Subject: Final Rule, Response to Petitions for Reconsideration, Technical Amendment, Docket No. 2008-0111, Anthropomorphic Test Devices; ES-2re Side Impact Crash Test Dummy 50th Percentile Adult Male.

First Technology Safety Systems (FTSS) has reviewed the February, 2008, ES-2re dummy drawing package (identified in the above mentioned technical amendment) and we have identified a number of drawing errors and a number of drawing issues. We seek to petition NHTSA to correct these drawings to ensure that the ES-2re dummy continues to meet the same dimensional and performance requirements established for the dummy when the dummy was proposed for inclusion into 49 CFR Part 572 Subpart U. FTSS makes the following comments and recommendations with respect to the drawing package. A marked up drawing for each of these recommended changes are attached to the end of this letter.

UNITS ARE mm		NATIONAL HIGHWAY TRAFFIC SAFETY ADMINISTRATION	
TOLERANCES ARE: * DECIMALS .X ±2.5 .XX ±0.25 .XXX ±0.127 * unless otherwise noted			
		LOWER NECK LOAD CELL ASSEMBLY	
		ES-2re	
SIZE B	DRAWING NUMBER SA572-S71-1		REV B

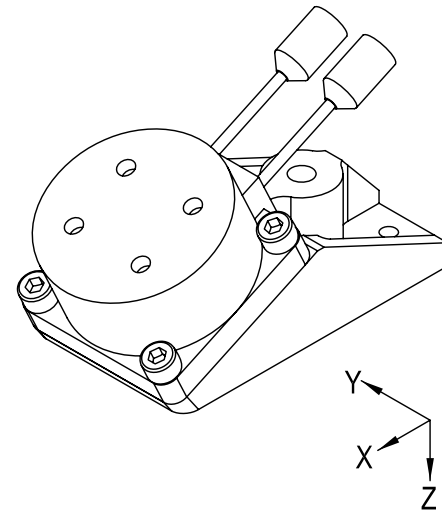
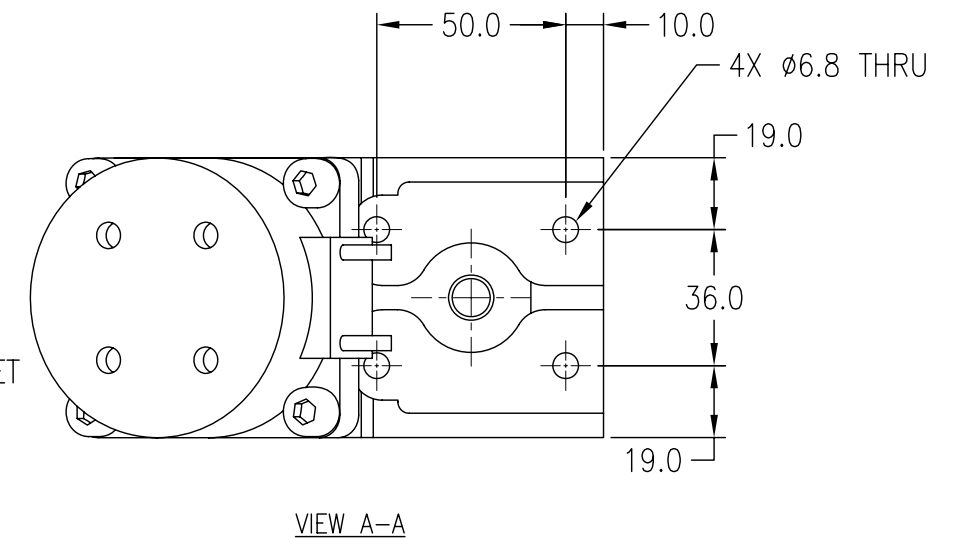
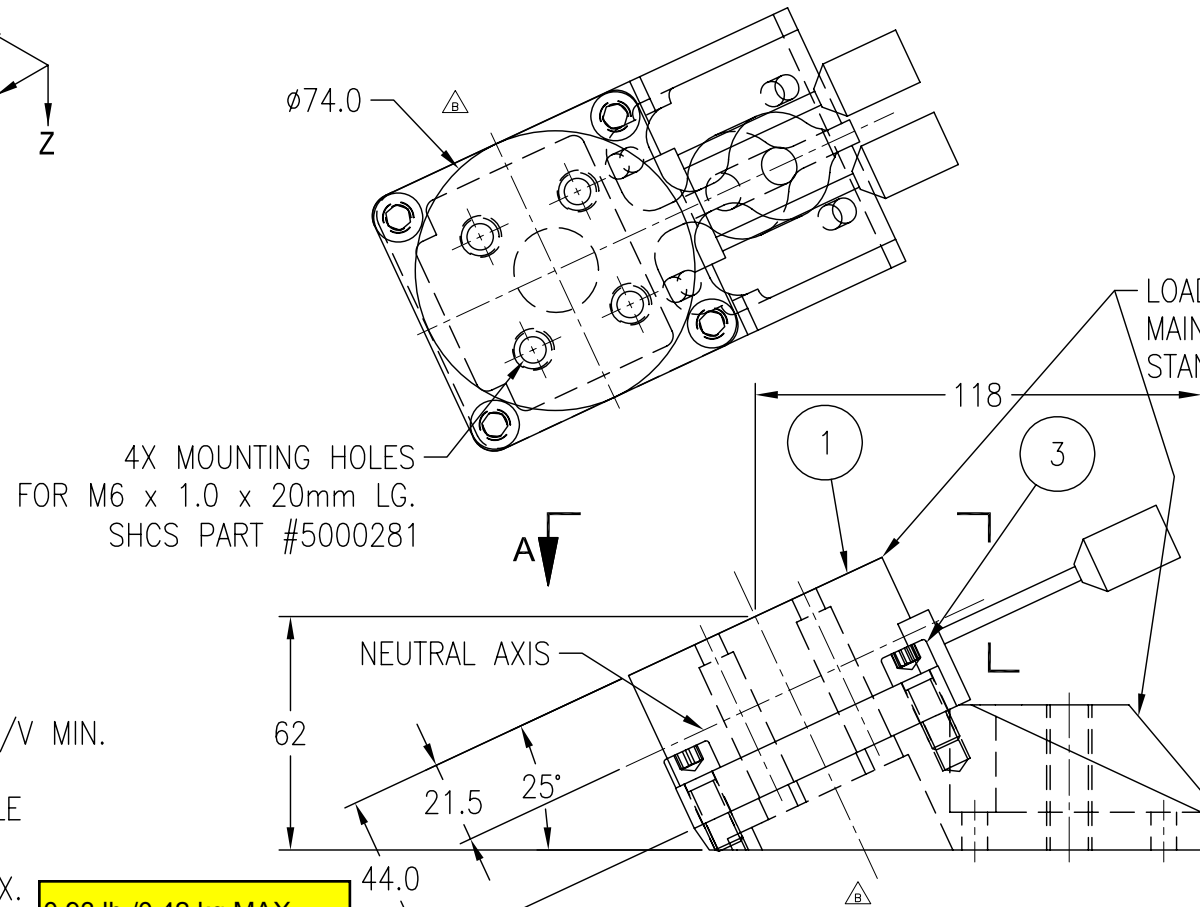
- 18) Drawing SA572-S71-1, Lower Neck Load Cell Assembly. FTSS recommends that specification of the part weight be correct to include the weight of the two connector/cable assemblies. The weight currently specified for this part in the NHTSA drawing is "0.8 lb. / 0.36 kg MAX." However, this weight does not include the weight of the electrical connector/cable assemblies. Since the cables are hard wired to the load cell, they need to be included in the total weight. Therefore, we request that the assembly weight be listed as "0.93 lb. / 0.42 kg MAX" to include the two cable assemblies.

WEIGHT: 0.8 lb./0.36 kg MAX. 0.93 lb./0.42 kg MAX.
